Regular Town Council Meeting

December 4, 2023

1. LDR Text Amendment to Neighborhood High Density-1 Zone (P23-168) (Tyler Valentine) -
This item will be continued to 1/8.
2. Development Plan for Mixed Use Building at 655 and 665 S. Cache Street (P23-105)
(Katelyn Page)

C3.2

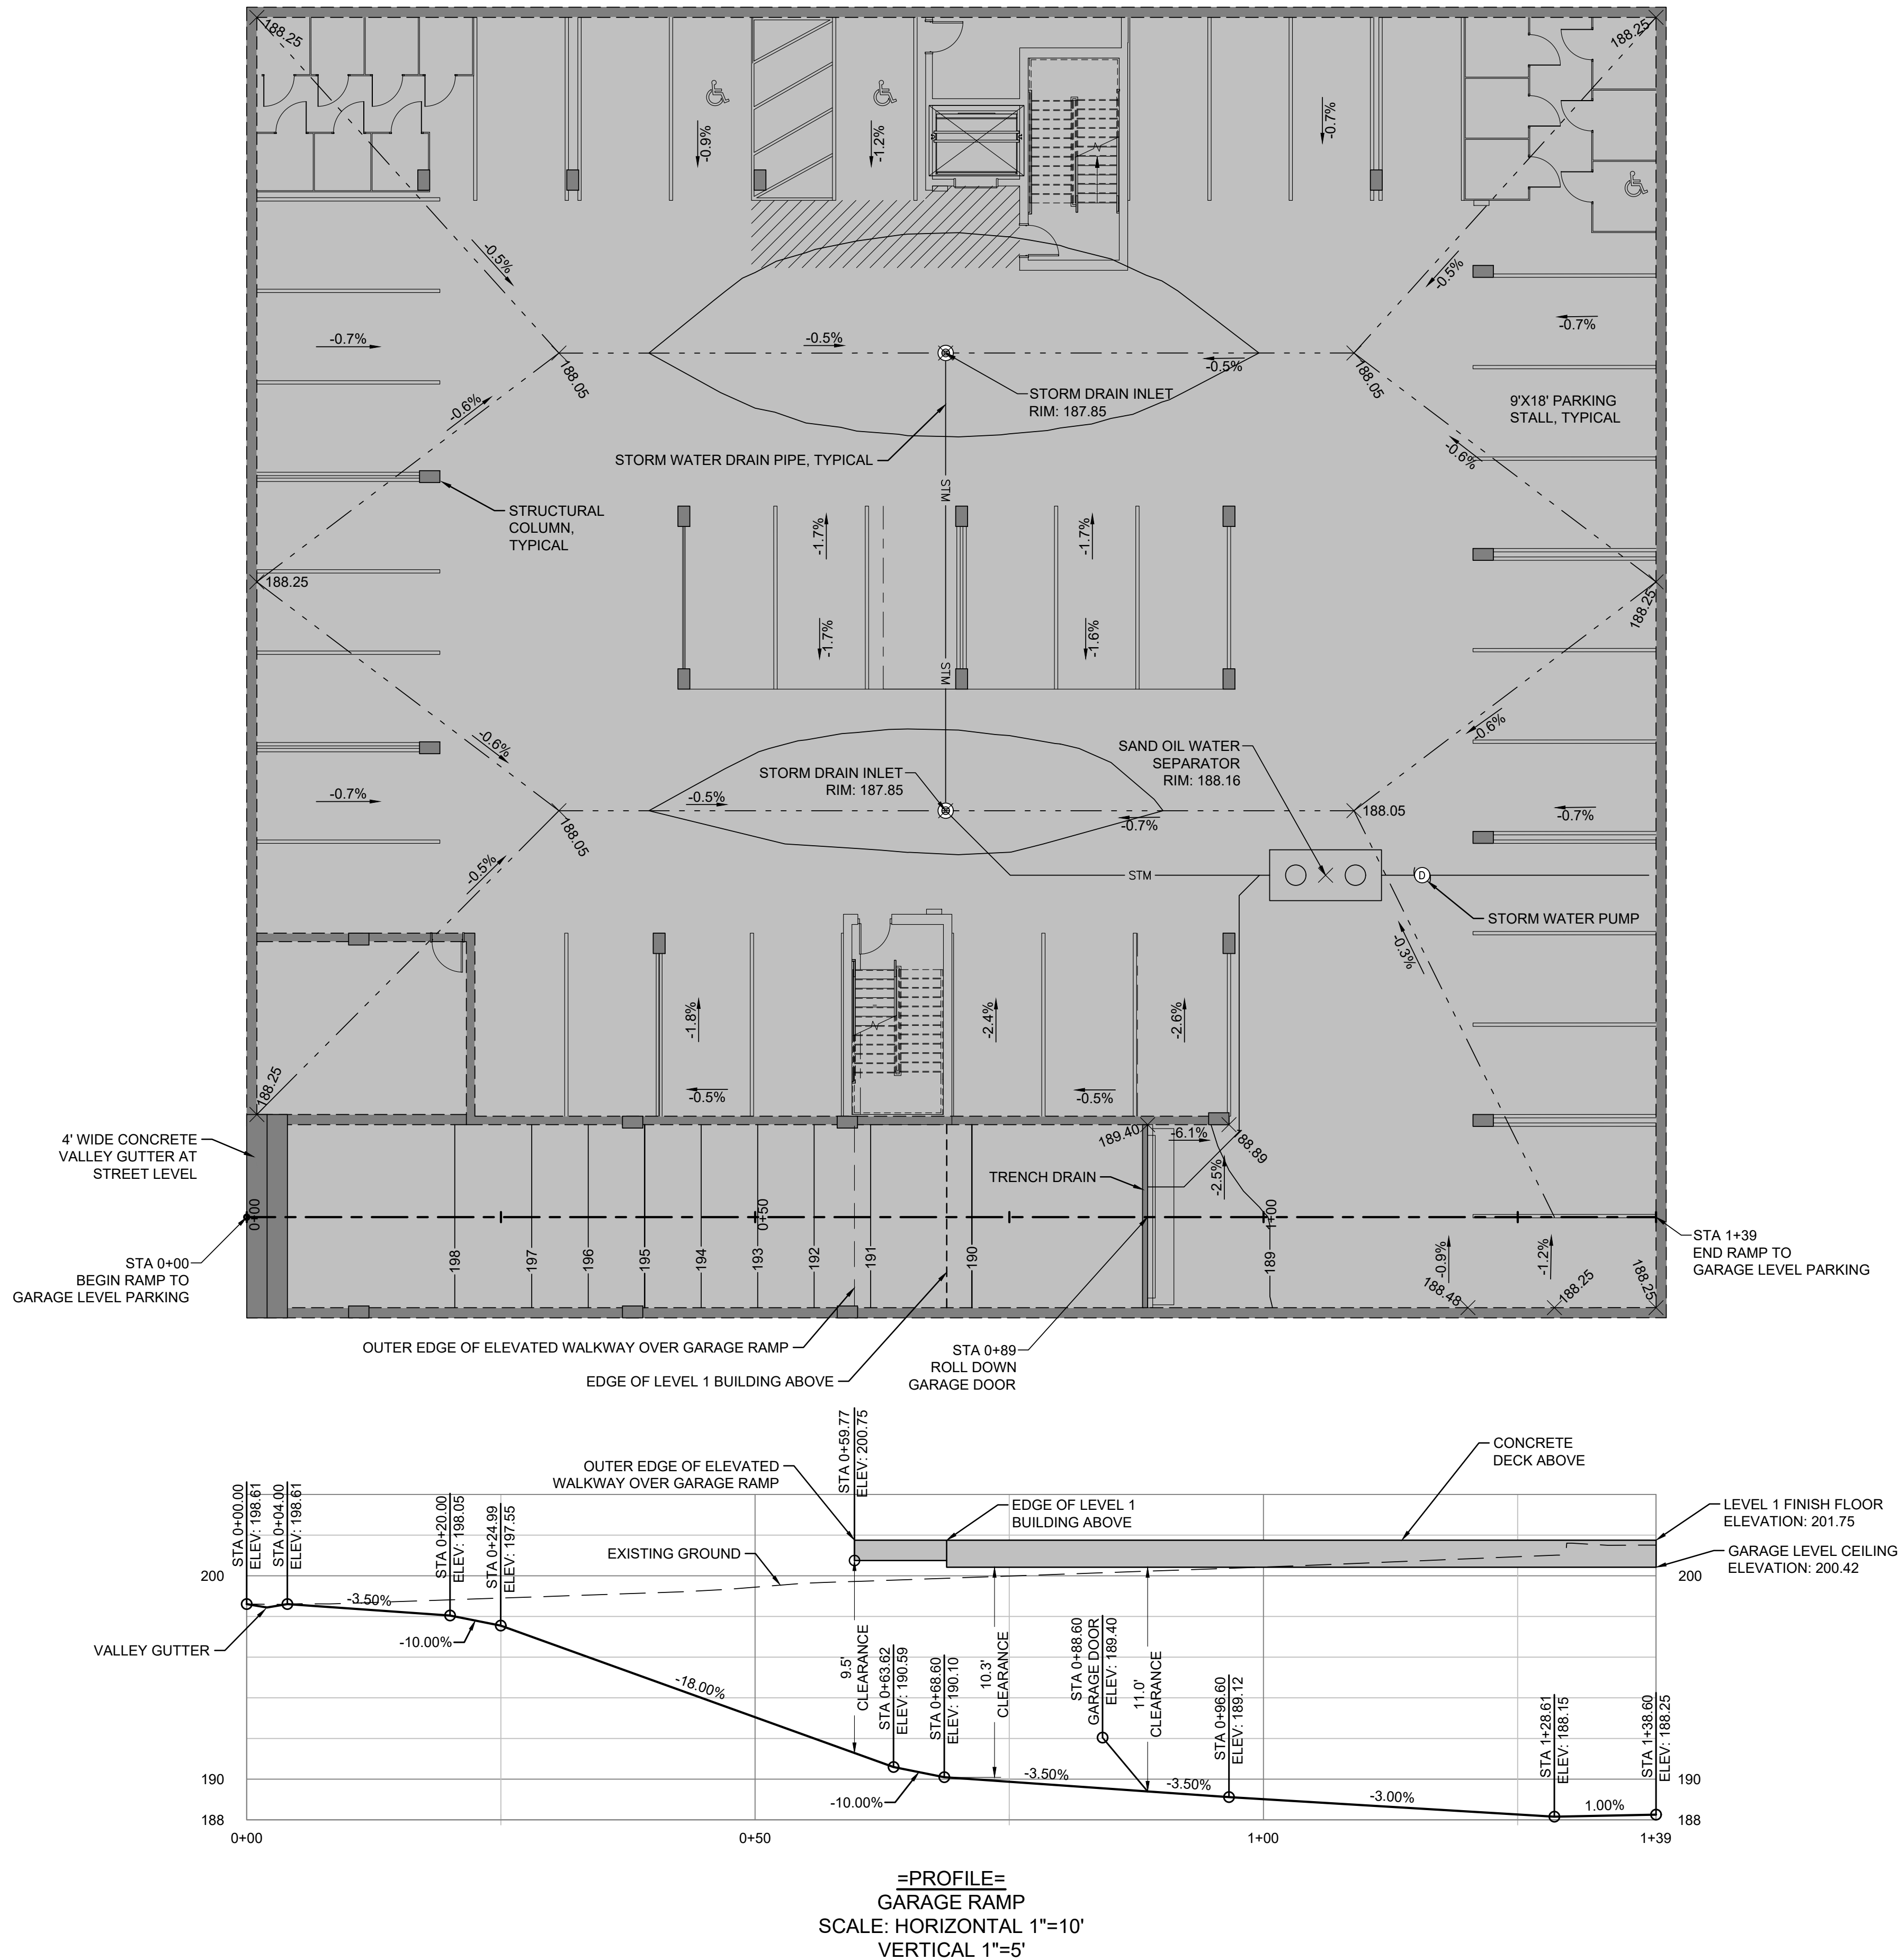
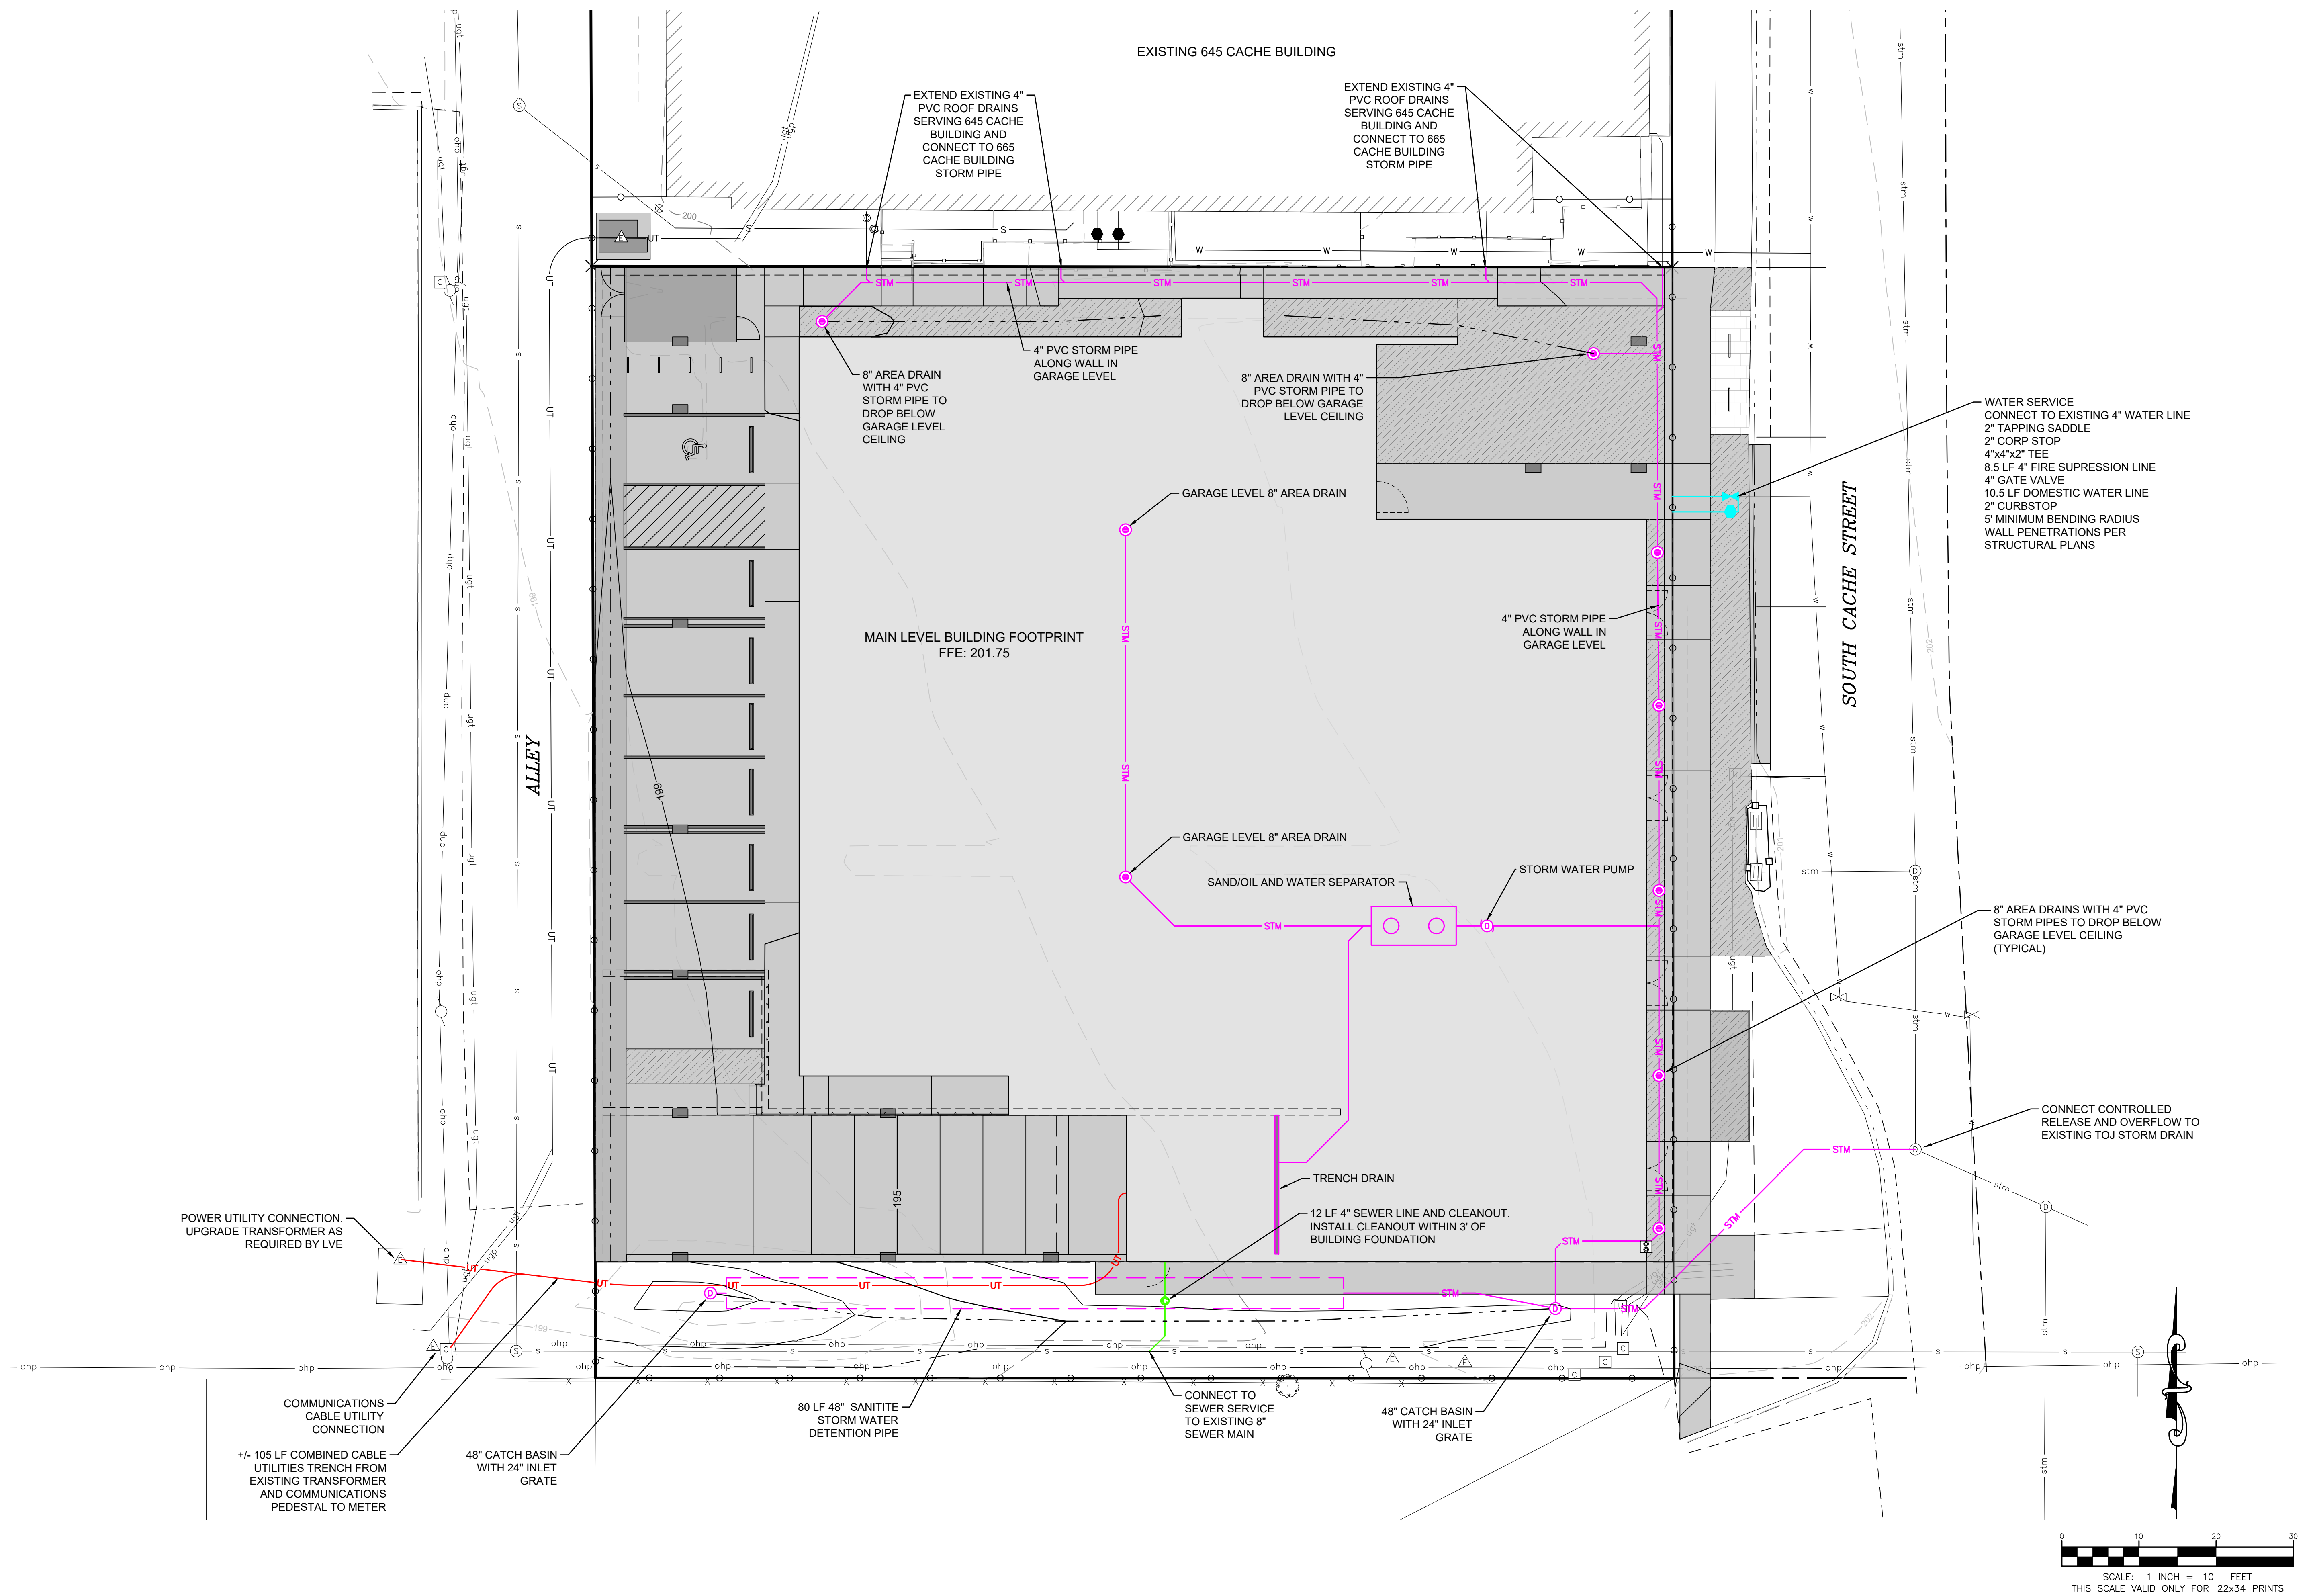
Verify structure setback to northern property line. Applicants LDR compliance table references 5 but A102 references 3-6 and civil C3.2 references 3.5 to structure. This setback is measured to structure and not to site development. See comment below on minimum sidewalk width.

Verify structure setback to eastern property line. Applicants LDR compliance table references 0 but A102 references 3-4 and civil C3.2 references 2.4 to a point that is not the actual structure. Staff notes location of property line is unclear on civil plan.

L0.3

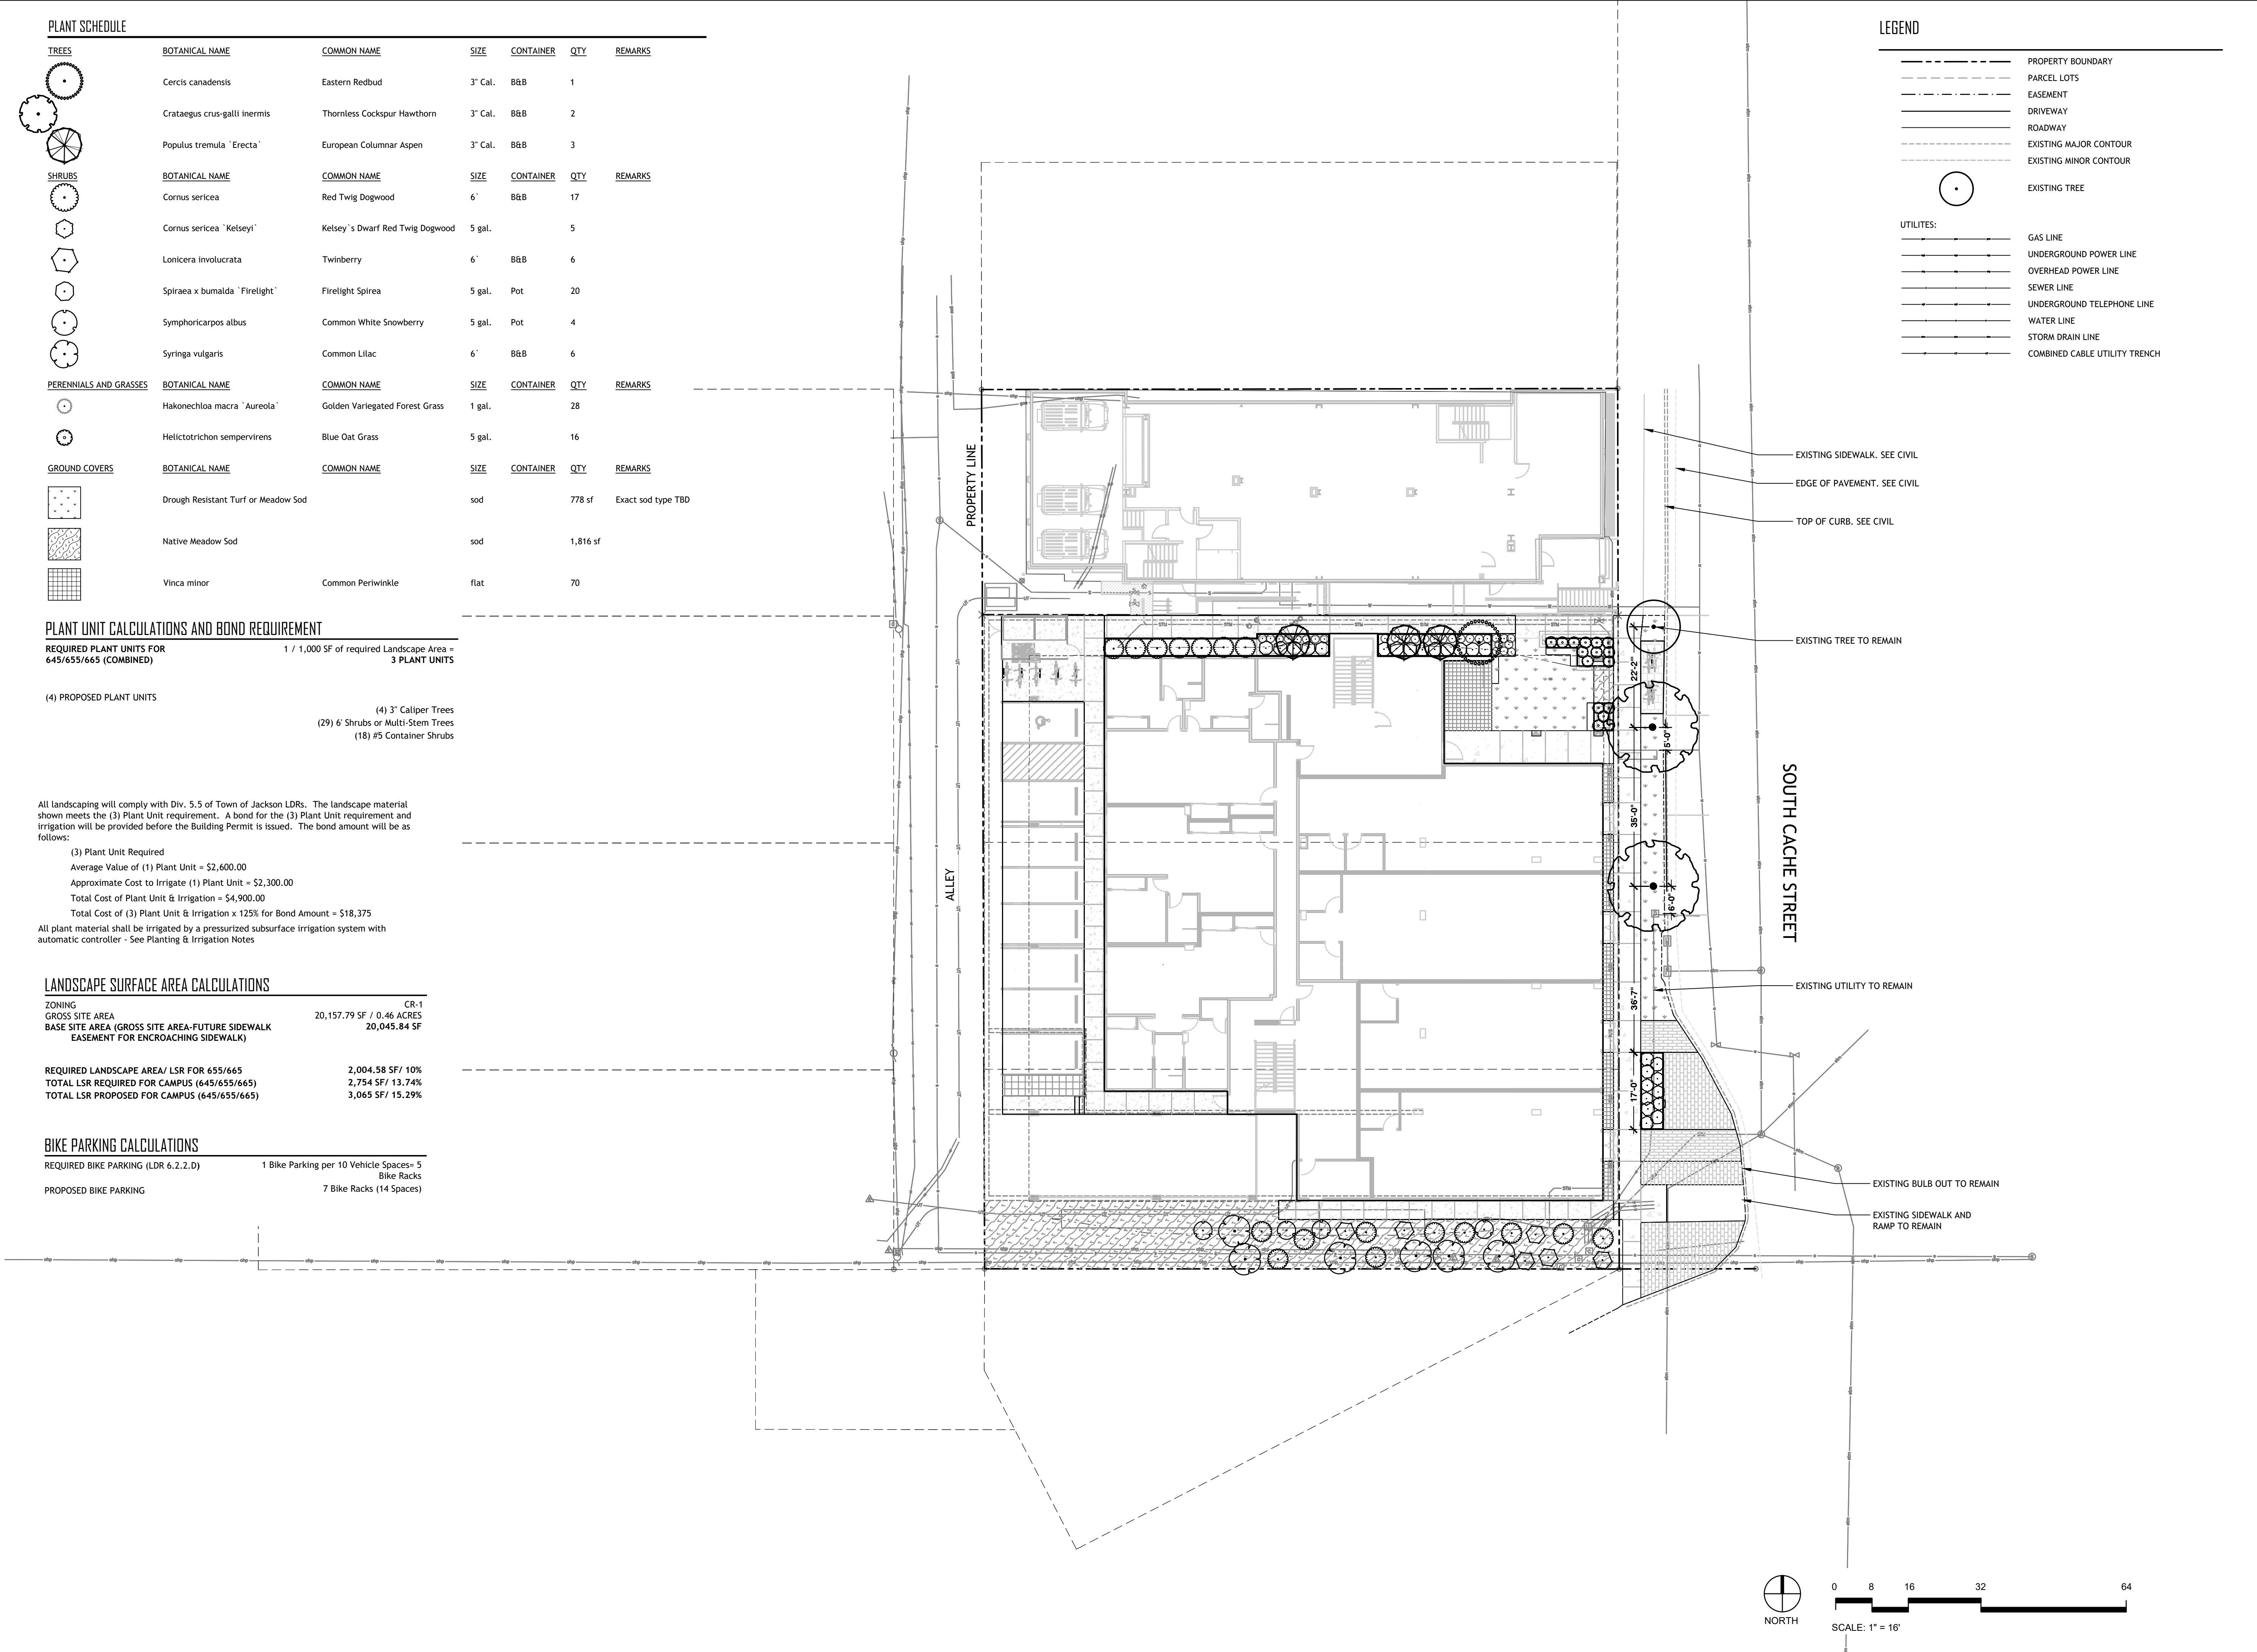
Prior to resubmittal, verify Landscape surface and plant unit calculations (L0.3). Based on proposed existing landscape area provided $(3013.89 - 940.54 = 2073.35)$ this would require 3 plant units for 655/665 S. Cache plus 2 required for 645 S. Cache = total 5 plant units. Staff notes that no plant units are required for tuck under parking (i.e. 1/12 space requirement). Staff estimates 5 plant unit total between 645-665 S. Cache.
